Crown Pastoral Land Tenure Review

Lease name: BERWEN

Public Submissions - Part 2

Tenure Review- Po 209 BERWEN - Preliminary Proposal

REVIEW OF PRELIMINARY PROPOSAL FOR BERWEN PASTORAL LEASE

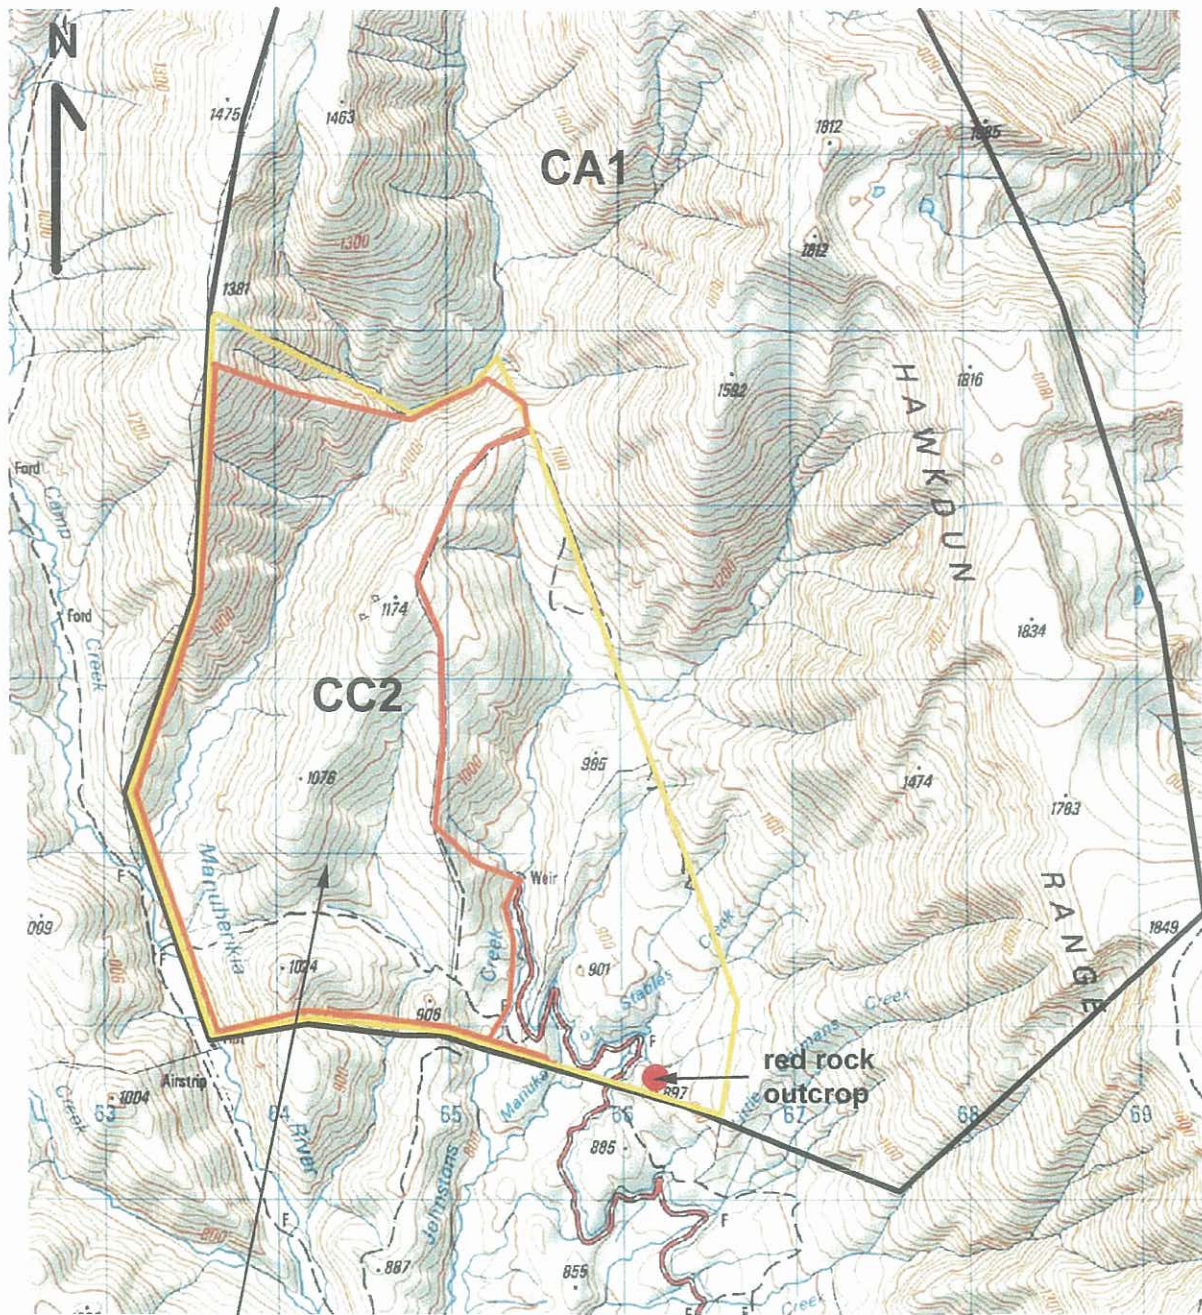
This covenanted area is supported. However if grazing is to continue the shrublands may have a limited life with few new seedlings establishing. The conditions need to include monitoring for recruitment

this area was recommended for conservation area because:
- it has dramatic rock outcrops harbouring remnant shrub species, and tall tussock at lower altitude;
- it is an important part of the more natural range backdrop to the Mackenzie Basin and SH8
- it is visually integral with the range to the south
- the proposed red line will result on a more coherent landscape outcome

this proposed line will result in an unnatural change in vegetation cover which is undesirable. This is inevitable with a simplistic 1000m contour choice as the boundary. The preferred line is the existing fence line.

Photo 1. The higher altitude land on the proposed freehold is similar in character and ecological value to the land in the proposed CA1. There is no basis for different management regimes.

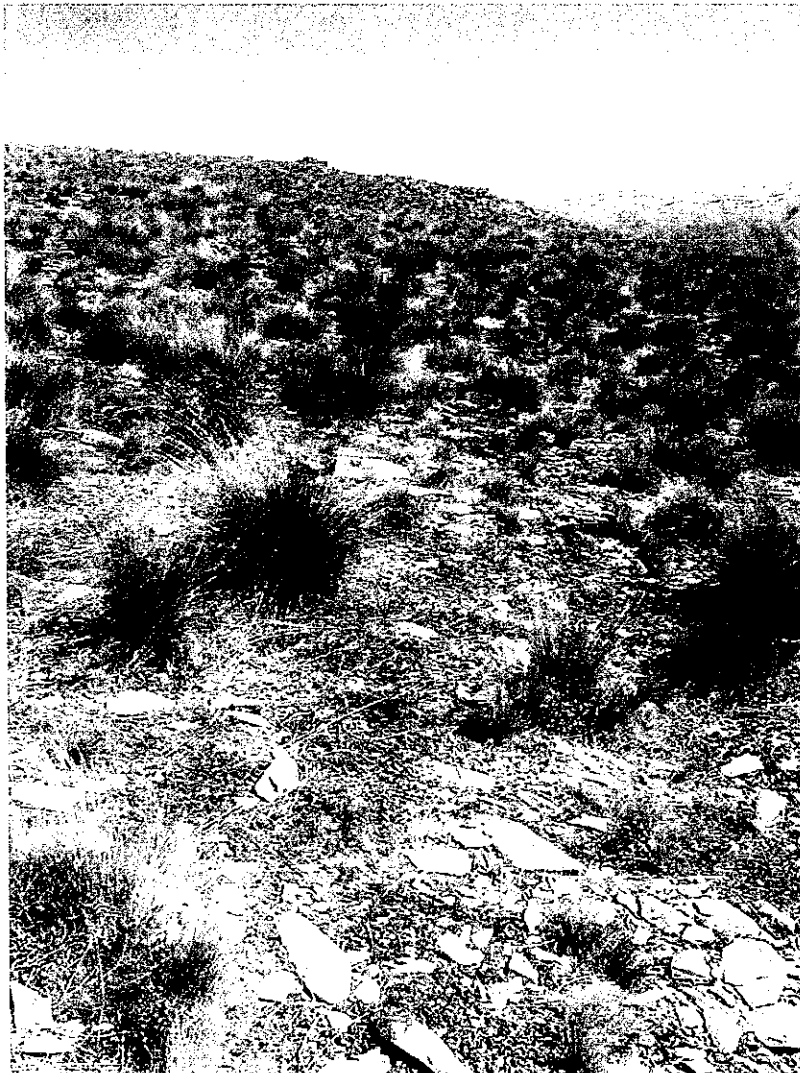
The areas have equal significant inherent values which deserve equal protection.

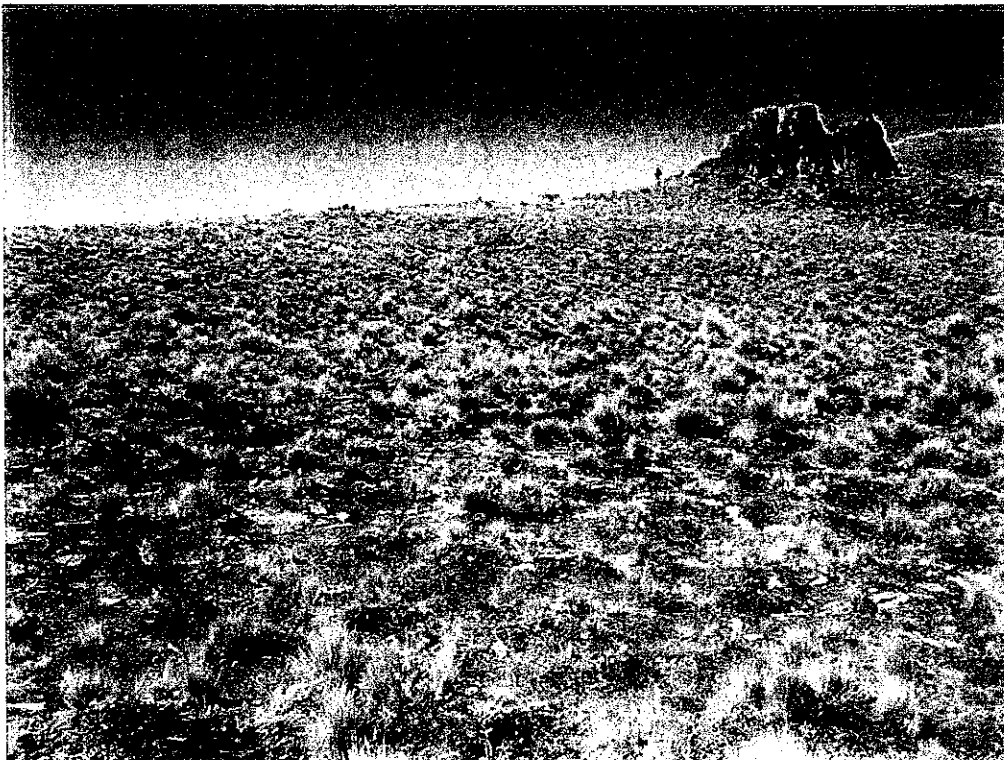
Above this altitude however, on the higher southeast corner (particularly over 1100m or so) the cover is markedly poorer, consisting of grazed out fescue and tall tussock with much bare ground vulnerable to frost heave and wind erosion (see Photo 2).

Photo 2. The land at the top end of the proposed freehold on the Ewe Range could not be farmed in an ecologically sustainable way. It is high altitude (up to 1420m altitude), relatively dry and north and west facing, and very exposed to high winds and dessicating conditions. Recovery of the tall tussock and subalpine shrub community would be prevented by continued grazing, especially in the absence of fertilizer (uneconomical to apply on this sort of country). This area is similar in character to that of the proposed CA1 and should be included in it. (photos taken by Anne Steven on 25 September 2005).

Photo 4.

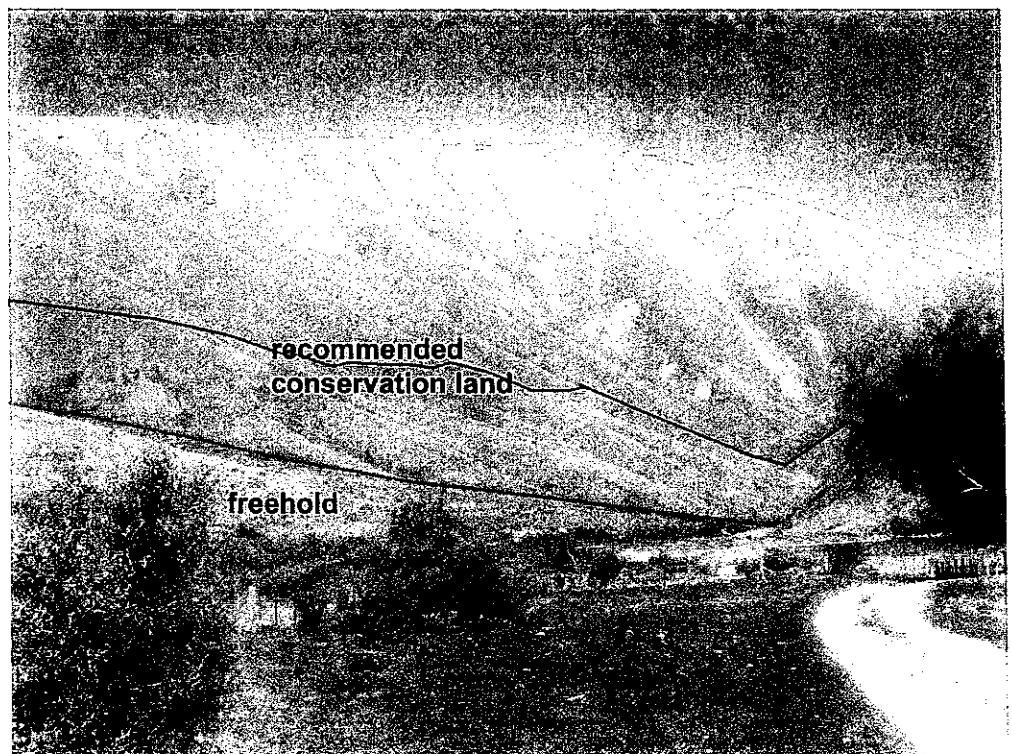
We would prefer this proposed fence be shifted north down the spur to a point nearer the creek bed (see attached Photo 4 and map).

The proposed freehold-conservation land boundary will result in undesirable fragmentation of the landscape, which currently has a high degree of intactness and coherence. This would result from intensified grazing with subsequent loss of tussock cover and increase in green exotic cover in contrast.

The long planar valley side slopes do not lend themselves to contour fencing. To avoid visual fragmentation and loss of valley floor to range top sequence, most, if not all the land south of the existing fence should be retained as conservation land.

proposed boundary (green) between conservation land and freehold, true right of Little Omarama Stream. Orange line is the preferred line.
